Answer to FCC Question

Applicant: Huawei Technologies Co., Ltd

Product Model Number: BTS3606 & BTS3606A

Figure 1 Radio Configuration list

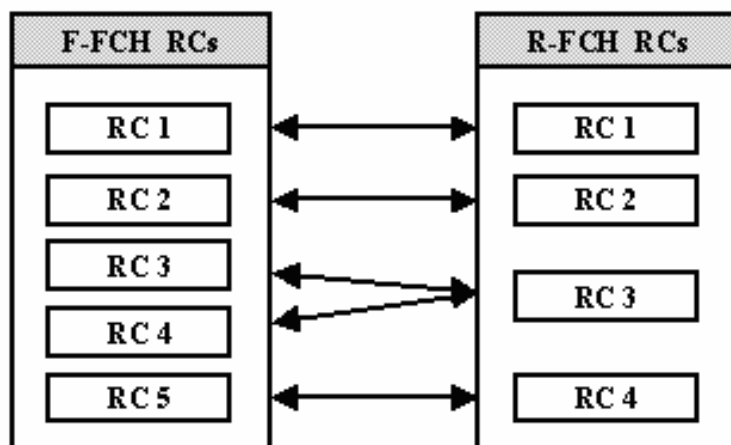
2) Please justify that test results represents all modes of CDMA2000 operation.

Huawei's CDMA Base Station BTS3606 & BTS3606A support forward channel RC1~RC5 and reward channel RC1~RC4. The supported radio configurations are listed in following figure1.
